CRACKED SPRING ROD NMC

Dear Editor,

If driving spring rod's cracked, get it replaced

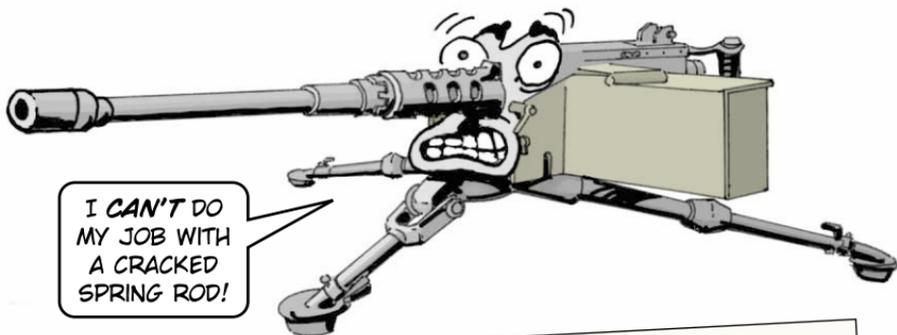
In our arms room inspections, we've noticed that almost half of the driving spring rods for our M2 machine guns are cracked, usually at the end of the rod. But when you check Step 24 in the PMCS in TM 9-1005-213-23, it says the rod's OK as long as it's not broken.

We feel the rod should be replaced if it's cracked.

The M2 experts at TACOM-Rock Island agree with you. In the next update to TM 9-1005-213-23, Step 24 will say the M2 is not fully mission capable if the driving spring rod is broken **or** cracked.
